CITY OF PORT PHILLIP
PORT PHILLIP PLANNING SCHEME
SECONDARY CONSENT APPROVAL
under Condition No. 2 in Planning Permit No: 742/2020
Note: This approval relates to ther indicated/highlighted area(s) only
Date: 6/09/2022 Sheet: 1 of 16

SCHEDULE OF CHANGES BY POINT ARCHITECTS DATED 21.04.2022 IS AS FOLLOWS:

POINT ARCHITECT'S RESPONSE TO THE PERMIT CONDITIONS DATED 14.01.2022 IS AS FOLLOWS:

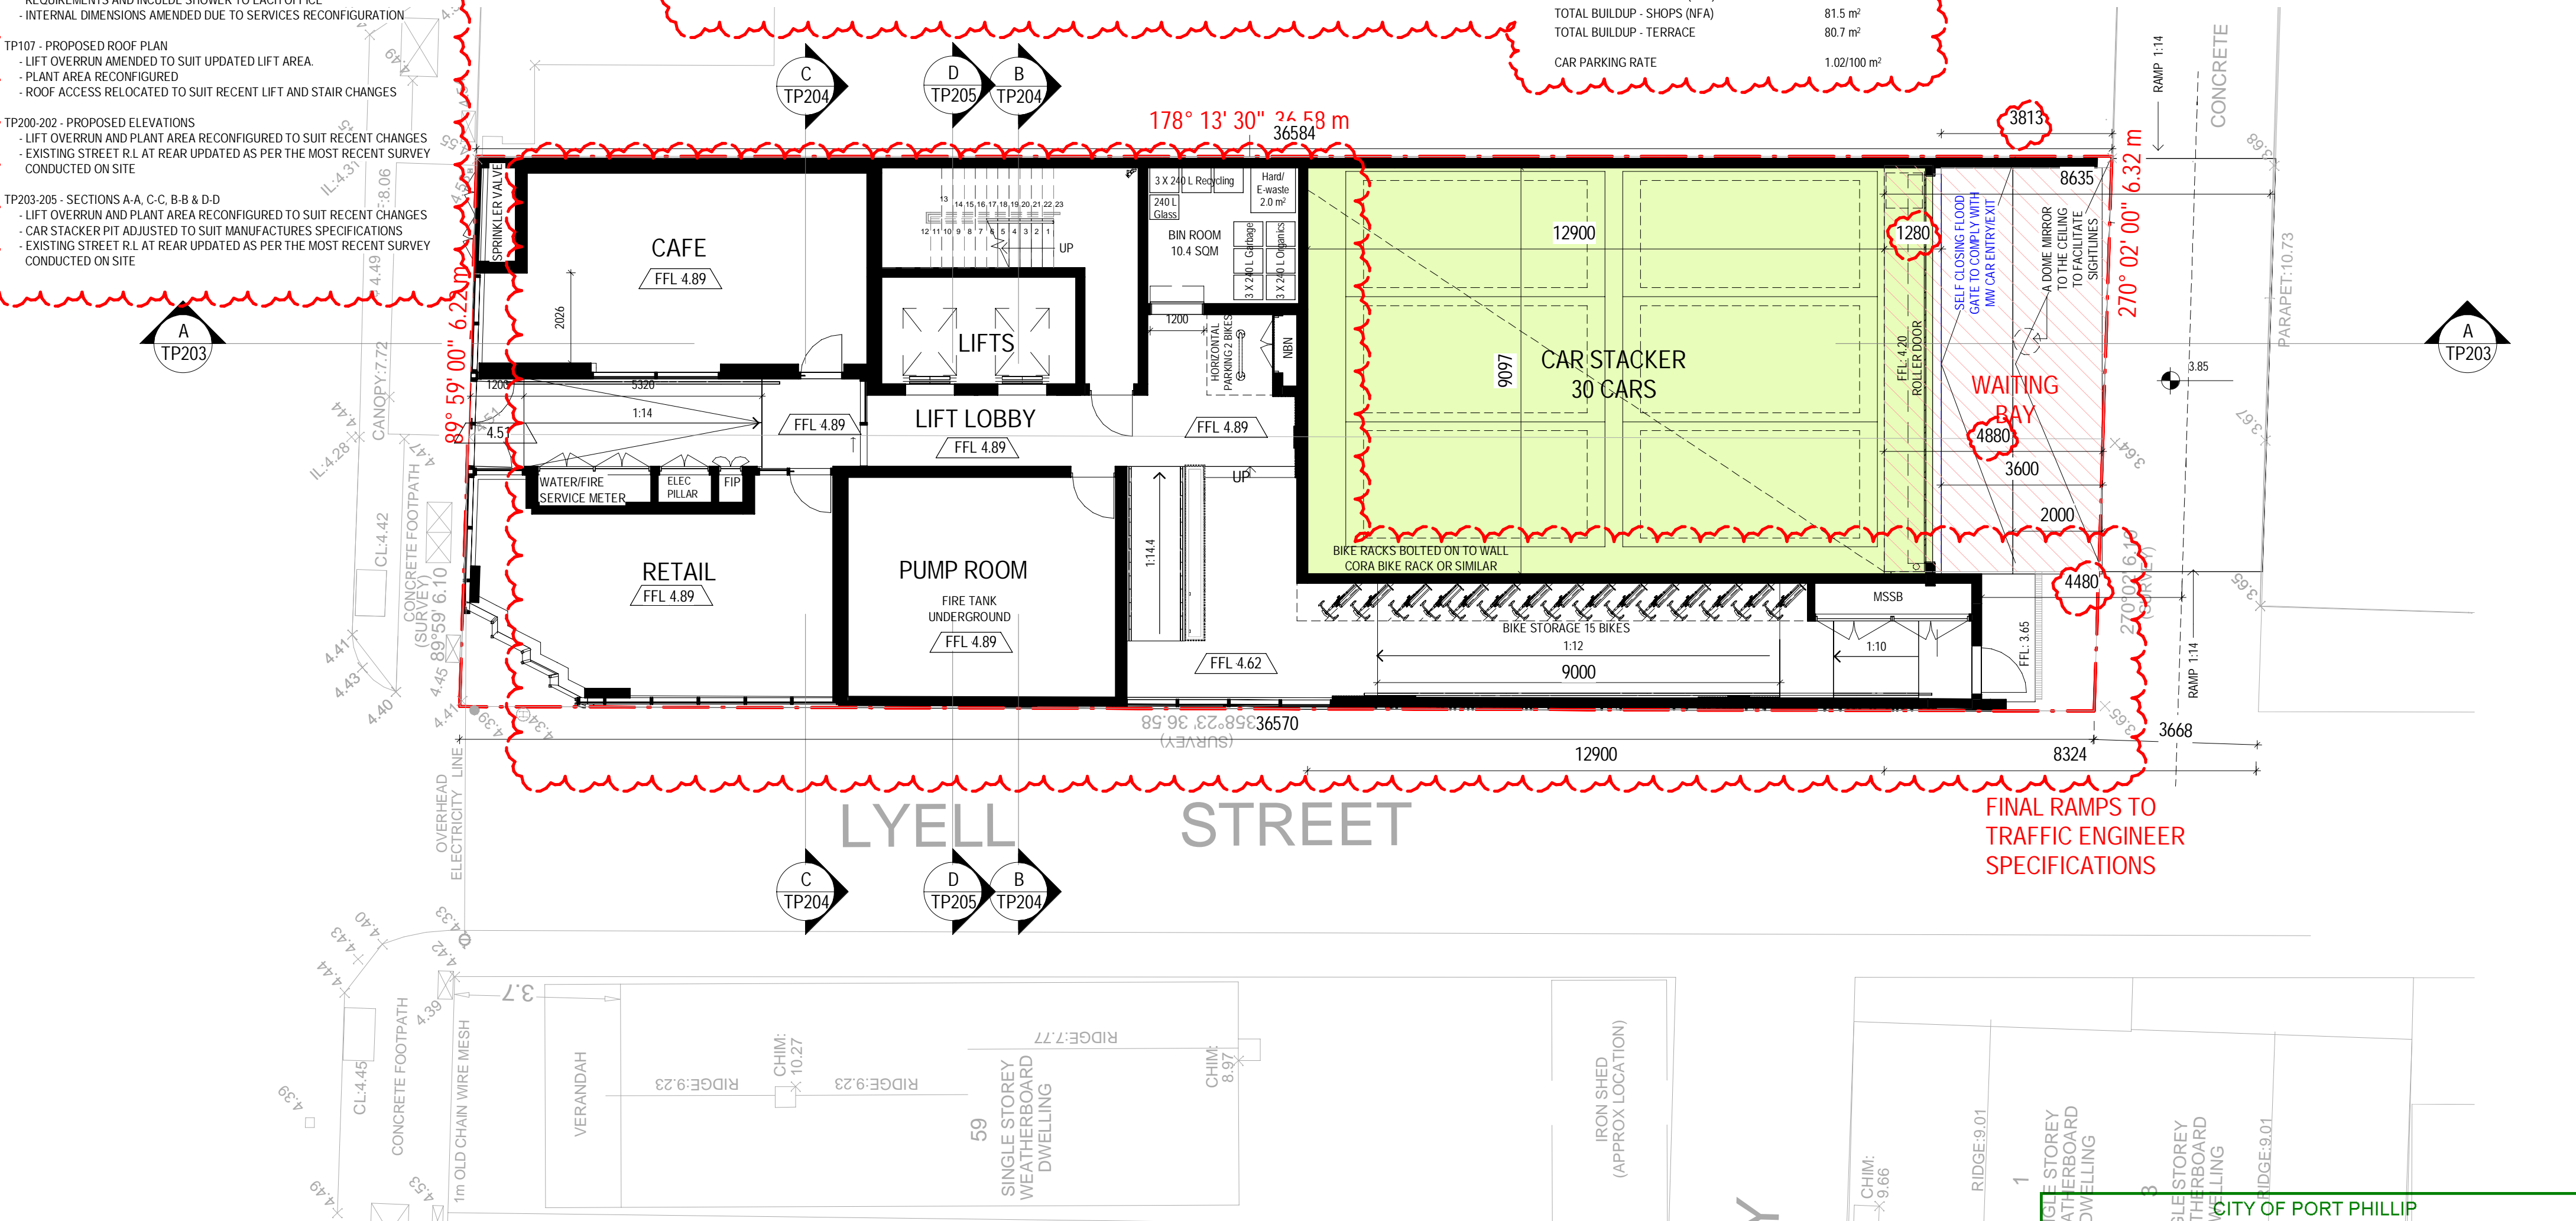
- TP002 - DESIGN RESPONSE**
 - LIFT OVERRUN AMENDED TO SUIT UPDATED LIFT AREA.
 - PLANT AREA RECONFIGURED
 - ROOF ACCESS RELOCATED TO SUIT RECENT LIFT AND STAIR CHANGES

CONDITION 1(a) Use of light/high transparency glass for the ground floor tenancies
 RESPONSE: Note added to TP 100, TP 200, TP 201 and TP202 to ensure use of light / high transparency glass for the ground floor tenancies

CONDITION 1(b) Increased depth of the level 6 planters together with depiction of an automatic watering system for the planter boxes.
 RESPONSE: Increased planter depth depicted and note regarding automatic watering system added on TP106, TP203, TP204 and TP205.

CONDITION 1(c) Depiction of lift overruns and plant areas on the elevations.
 RESPONSE: Plant screen and lift over run depicted on TP 107, TP200, TP 201, TP202, TP203, TP204 and TP205.

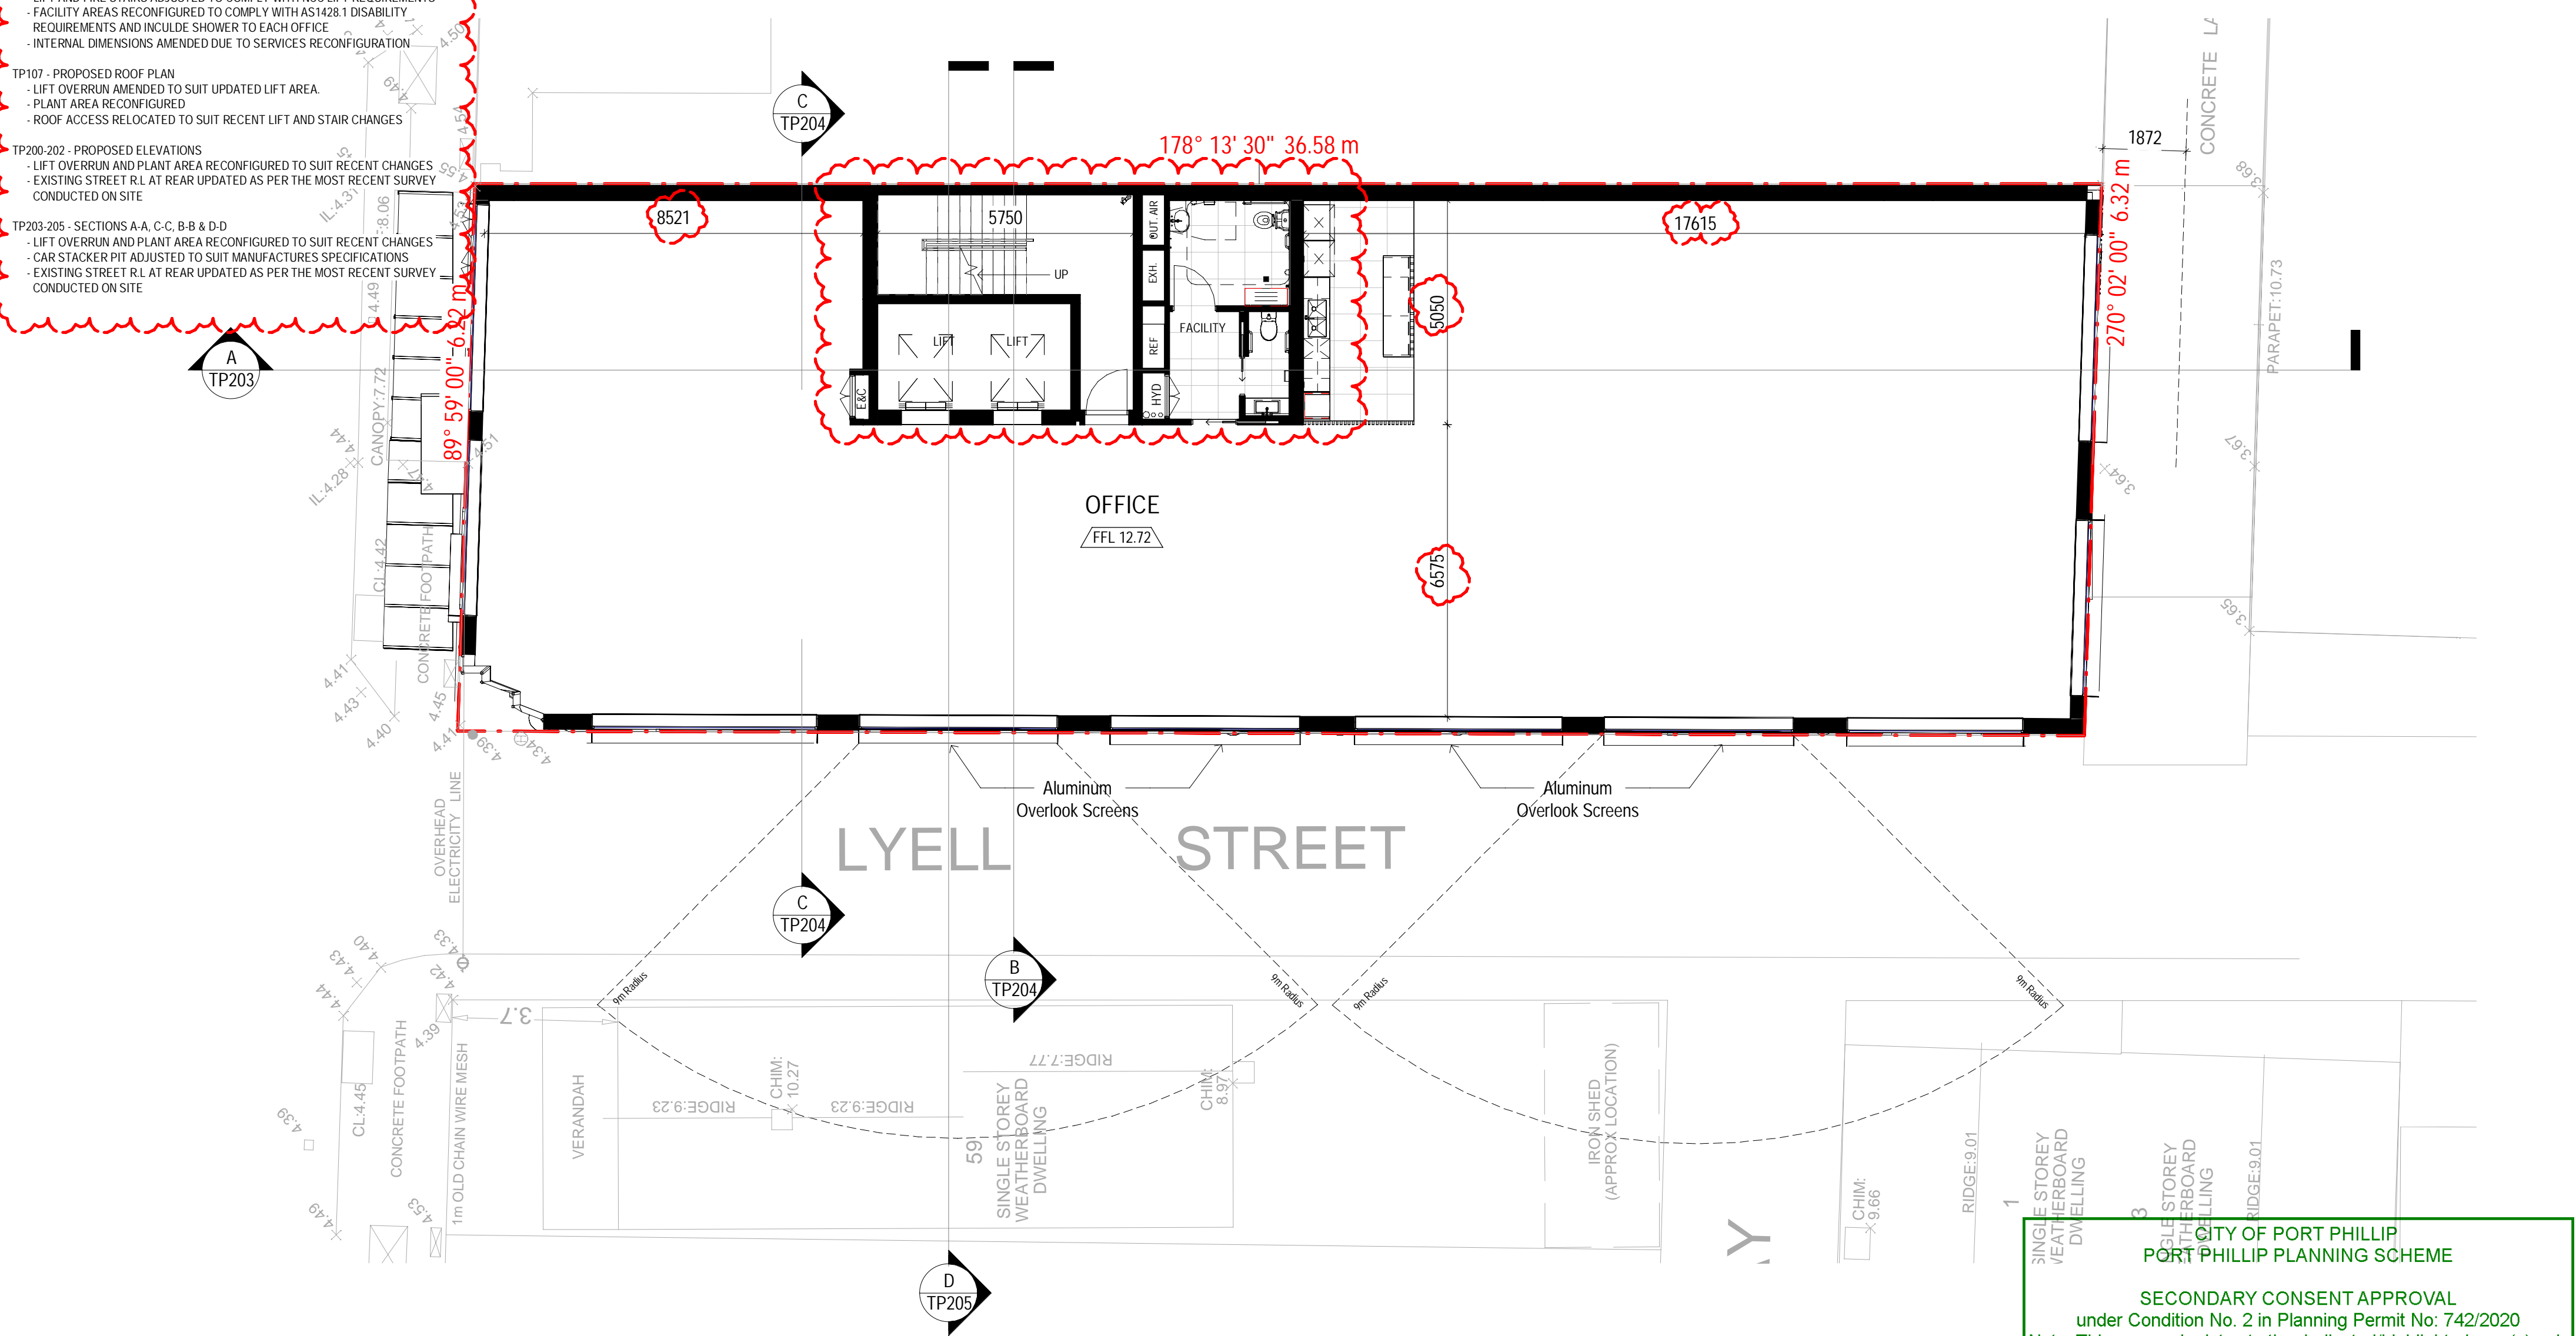
- TP100 - PROPOSED GROUND FLOOR PLAN
 - PUMP ROOM ALLOCATION INCREASED AS PER SERVICES ENGINEERS REQUIREMENT
 - BIN ROOM RELOCATED TO SUIT NEW LAYOUT
 - ENTRY RAMP REDESIGNED TO ACCOMMODATE SERVICES CUPBOARDS & COMPLY TO AS1428.1

- REAR ACCESS REDESIGNED FOR EASE OF ACCESS & COMPLY TO AS1428.1
 - LIFT AND FIRE STAIRS ADJUSTED TO COMPLY WITH NCC LIFT REQUIREMENTS
 - REAR ENTRY PUSHED OUT TO ALLOW FOR SERVICE REQUIREMENTS

POINT ARCHITECT'S RESPONSE TO THE PERMIT CONDITIONS DATED 14.01.2022 IS AS FOLLOWS:

- CONDITION 1(a) Use of light/high transparency glass for the ground floor tenancies
 RESPONSE: Note added to TP 100, TP 200, TP 201 and TP202 to ensure use of light / high transparency glass for the ground floor tenancies
- CONDITION 1(b) Increased depth of the level 6 planters together with depiction of an automatic watering system for the planter boxes.
 RESPONSE: Increased planter depth depicted and note regarding automatic watering system added on TP106, TP203, TP204 and TP205.
- CONDITION 1(c) Depiction of lift overruns and plant areas on the elevations.
 RESPONSE: Plant screen and lift over run depicted on TP 107, TP200, TP 201, TP202, TP203, TP204 and TP205.

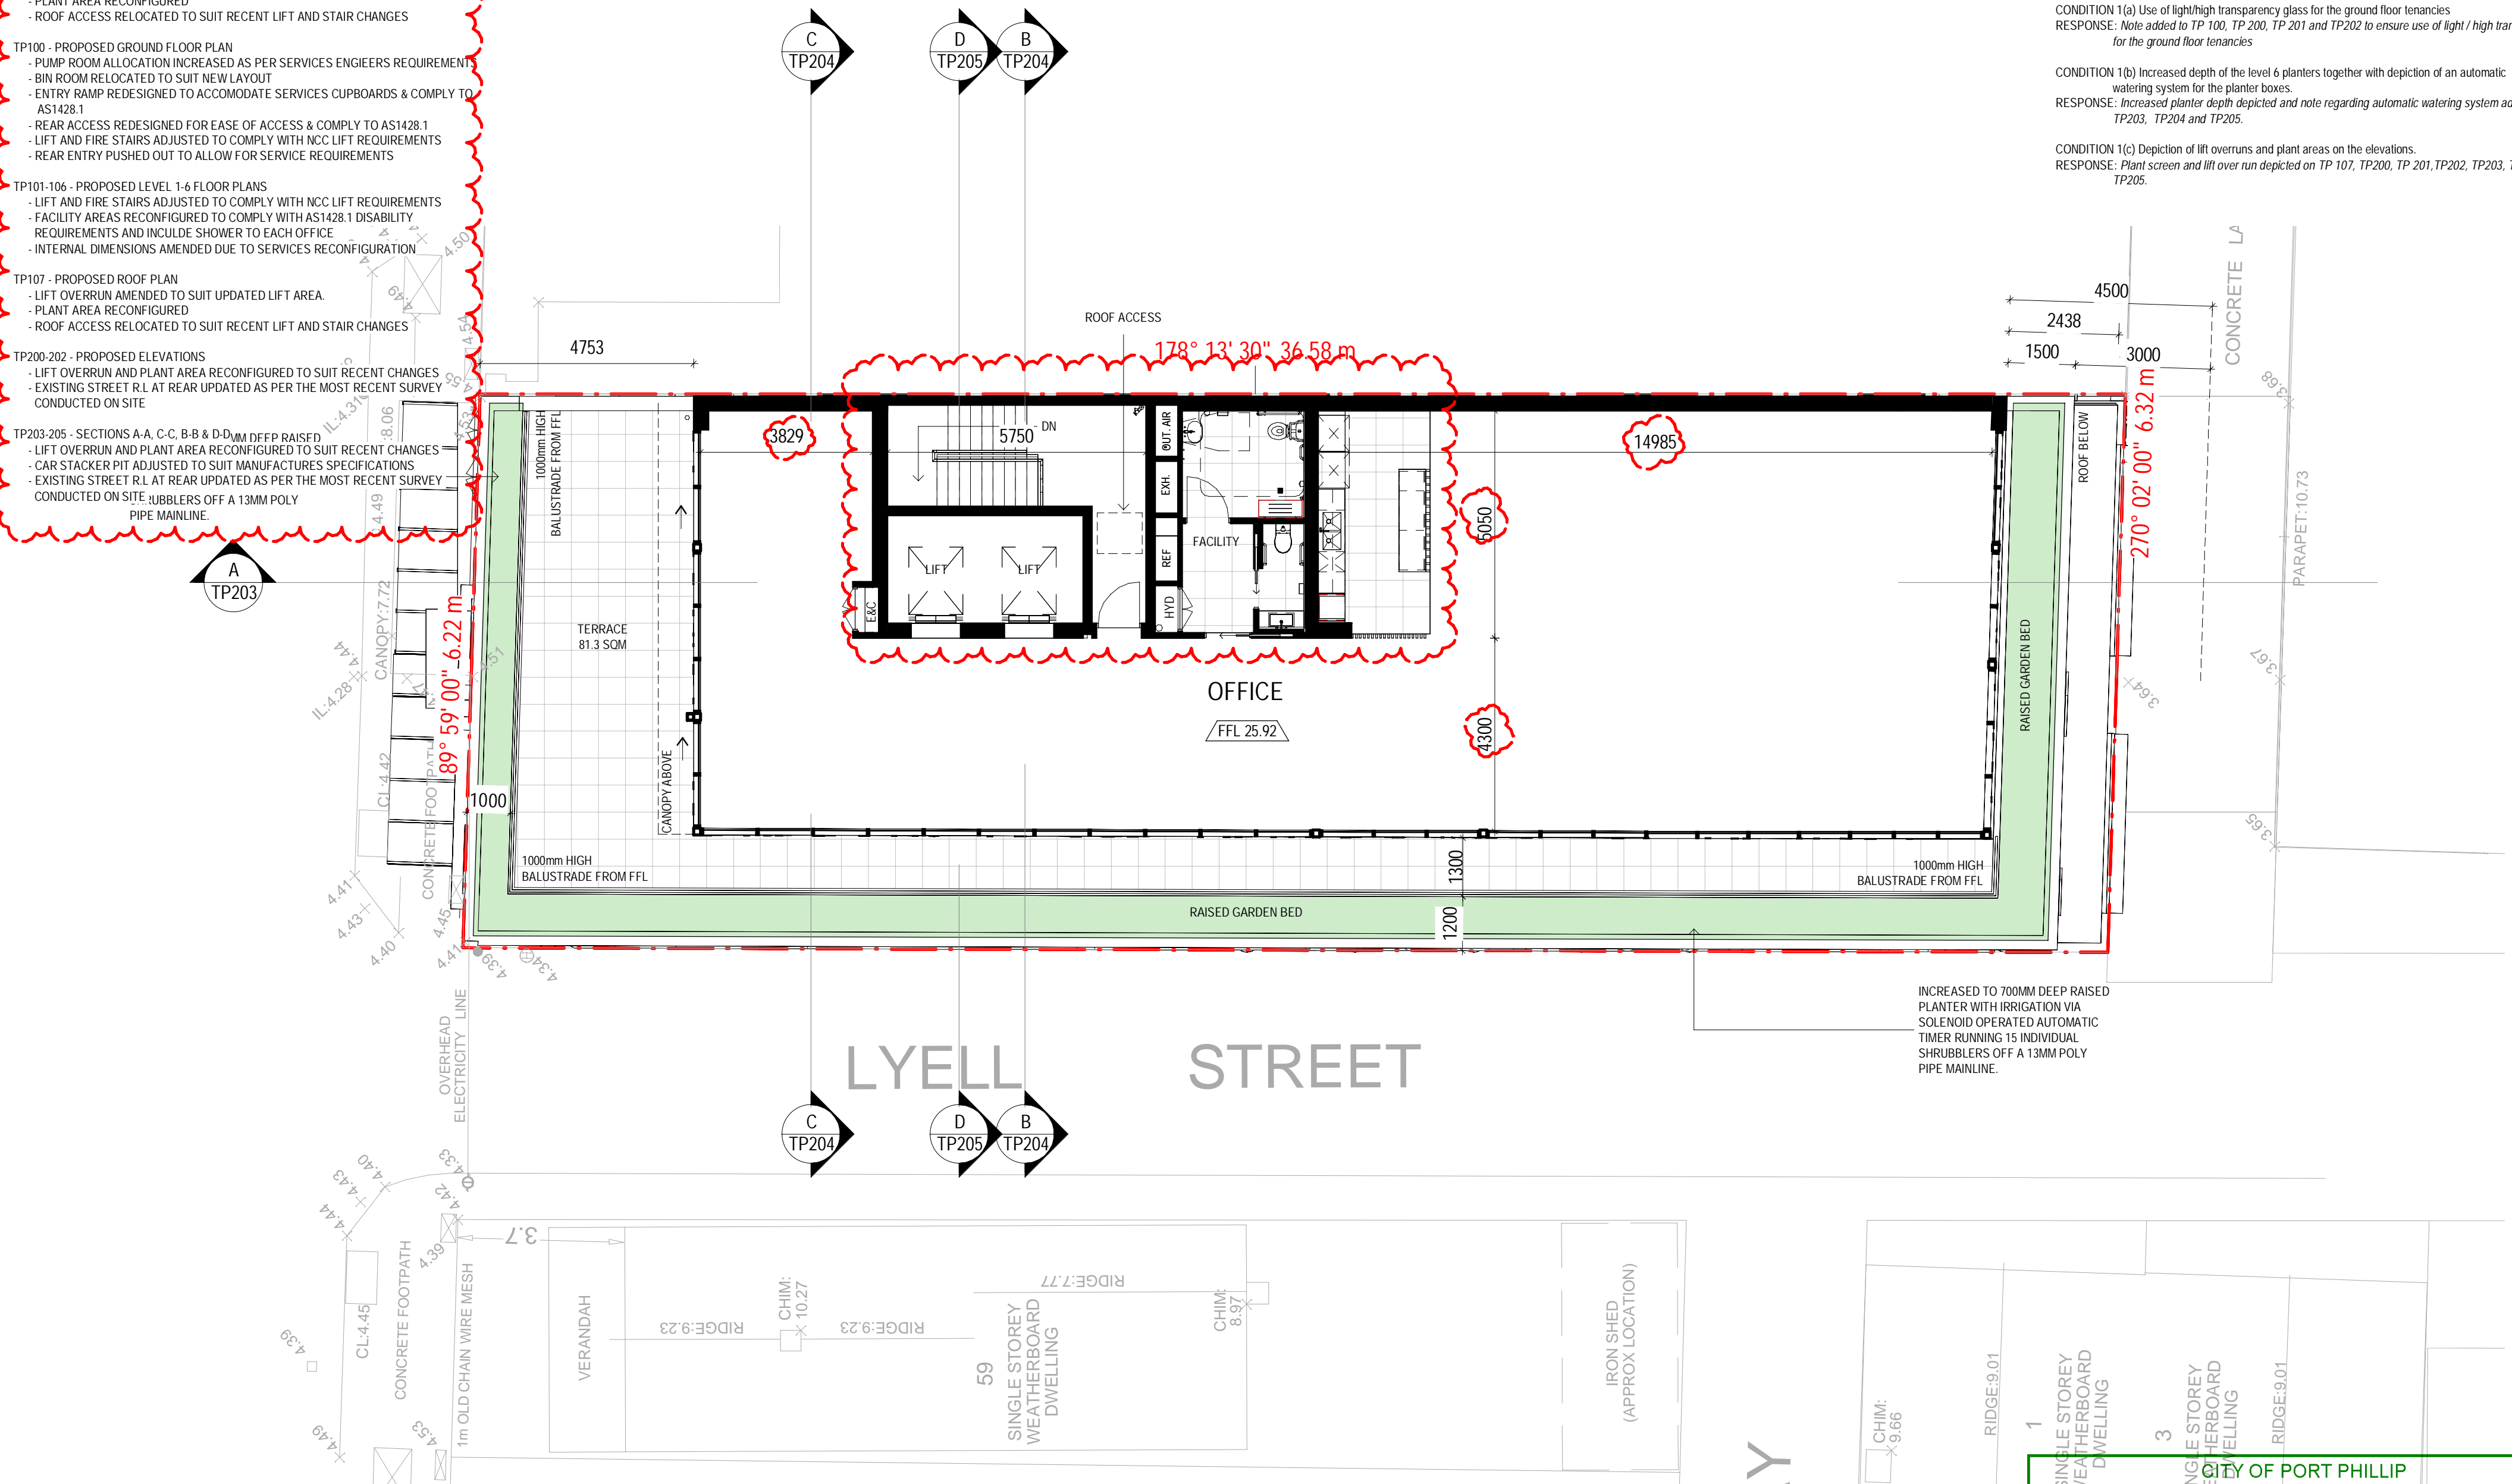
- CONDITION 1(a) Use of light/high transparency glass for the ground floor tenancies
 RESPONSE: Note added to TP 100, TP 200, TP 201 and TP202 to ensure use of light / high transparency glass for the ground floor tenancies
- CONDITION 1(b) Increased depth of the level 6 planters together with depiction of an automatic watering system for the planter boxes.
 RESPONSE: Increased planter depth depicted and note regarding automatic watering system added on TP106, TP203, TP204 and TP205.
- CONDITION 1(c) Depiction of lift overruns and plant areas on the elevations.
 RESPONSE: Plant screen and lift over run depicted on TP 107, TP200, TP 201, TP202, TP203, TP204 and TP205.

INCREASED TO 700MM DEEP RAISED PLANTER WITH IRRIGATION VIA SOLENOID OPERATED AUTOMATIC TIMER RUNNING 15 INDIVIDUAL SHRUBBLERS OFF A 13MM POLY PIPE MAINLINE.
